Response to review comments on gmd-2019-106 'ACCESS-OM2: A Global Ocean-Sea Ice Model at Three Resolutions' - Geoscientific Model Development

Comments from Referee #1 (Pat Hyder, Met Office)

Top two plots: Arctic and Antarctic sea ice volume by category in initial spinup at 0.25deg.

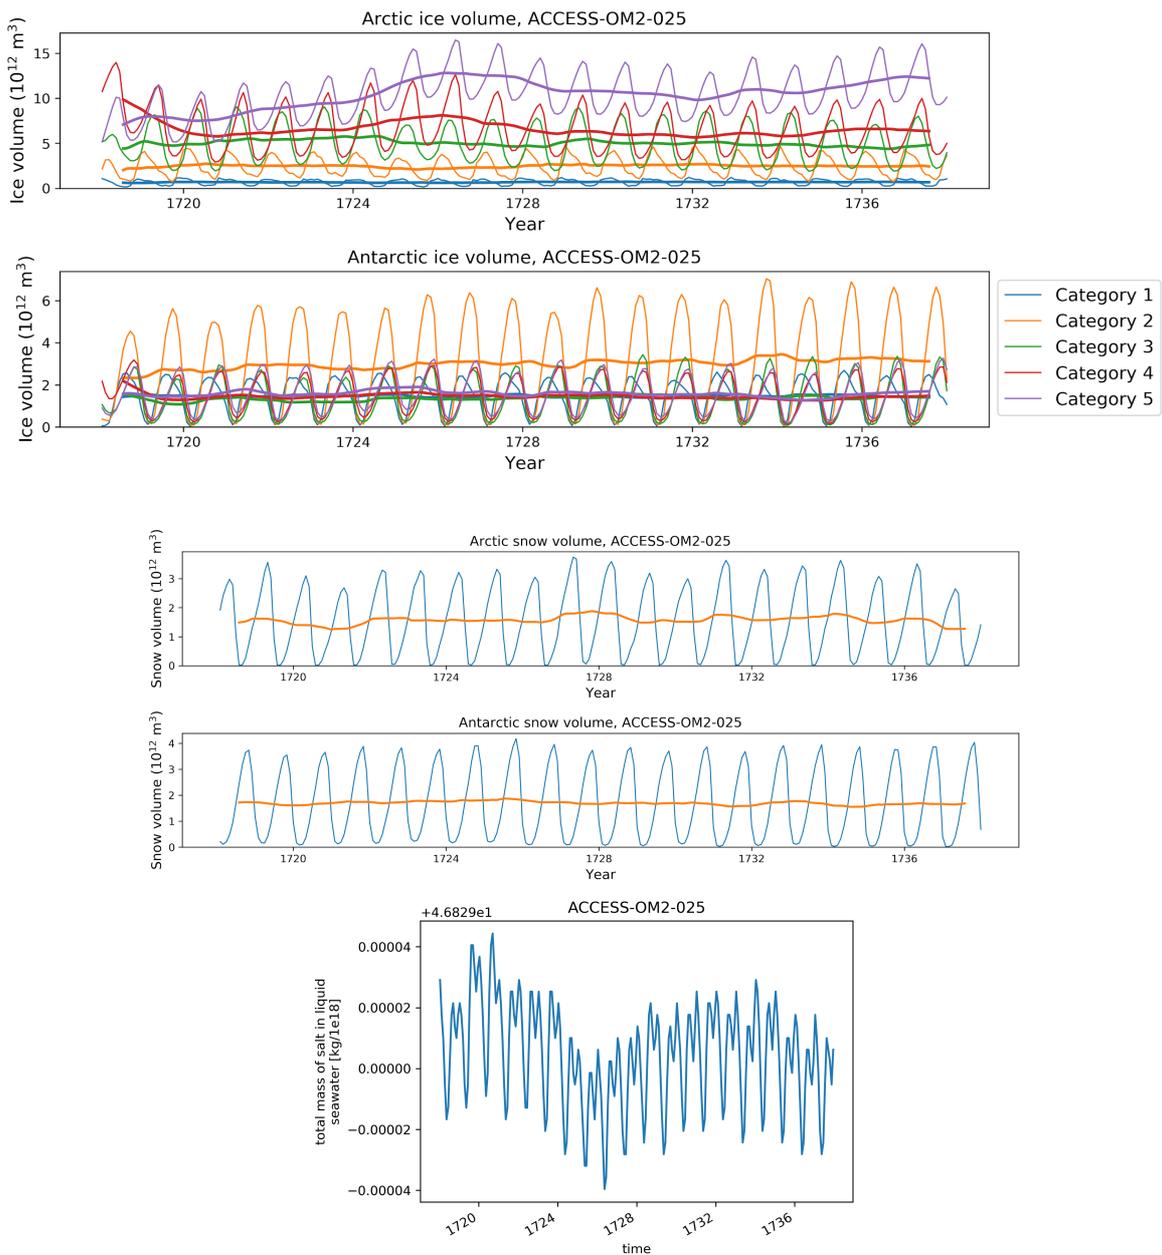
Page 10 line 22-24 - We tend to start sea-ice off from the restart file of a separate spun up run to avoid contaminating the salinity with melt/formation as the ice-spins up. However, perhaps this does not matter too much when you run the models for such a long time?

The sea-ice initial condition is described in the paper. Importantly, it is not an ice-free condition. The total sea ice volume in this initial condition is close enough to the adjusted state that there is no significant drift in total ocean salt mass as the sea ice spins up (see figures for ACCESS-OM2-025 below; other resolutions are similar). We have added this clarifying text: *The total sea ice and snow volumes in this initial condition are very close to the adjusted state; there is therefore no significant drift in total ocean salt as the sea ice spins up.*

Next two plots: Arctic and Antarctic snow volume in initial spinup at 0.25deg.
Bottom row: monthly mean total mass of ocean salt in the first several years at 0.25deg.
The top four plots show monthly means and 12-month rolling means.
The ocean salt plots have large offsets indicated at the top of the y-axes. The annual cycles are due to sea ice formation and melting, which vary the total ocean salt by less than one part in 10^6 .

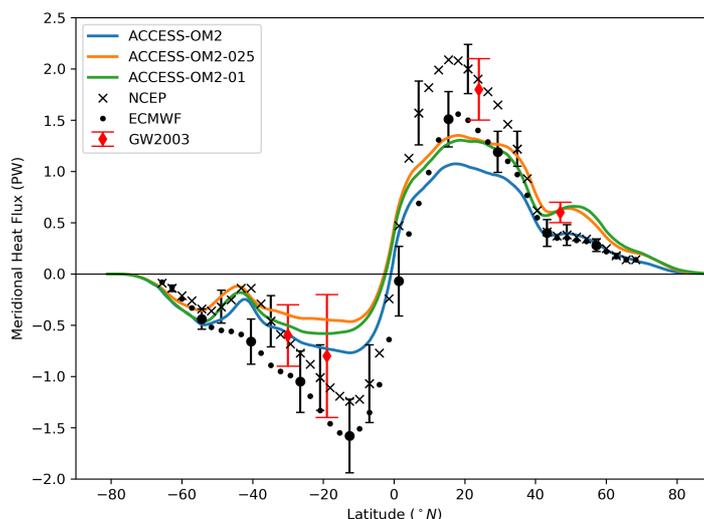
Page 25 line 4 & fig 13 - This probably doesn't make much difference for your long averaging period but does the Trenberth and Carron method assume equilibrium, i.e. no heat content tendency.

Trenberth and Caron (2001) do not assume an exact equilibrium for the ocean heat content tendency. As part of several adjustments that are made to the raw residual-inferred ocean heat transport calculations to account for biases and tendency, they subtract a constant 0.3Wm^{-2} globally from the fluxes to account for background warming (estimated from Levitus et al. 2000, Warming of the world ocean, Science 287, 2225-2229). However, they do ignore other changes in ocean heat storage (e.g. regional changes, interannual variability) because they do not have sufficient data available to assess them (although they do argue that they are small). We have now included error bars for the Trenberth and Caron (2001) curves in Fig. 13 (see below) to capture these uncertainties.
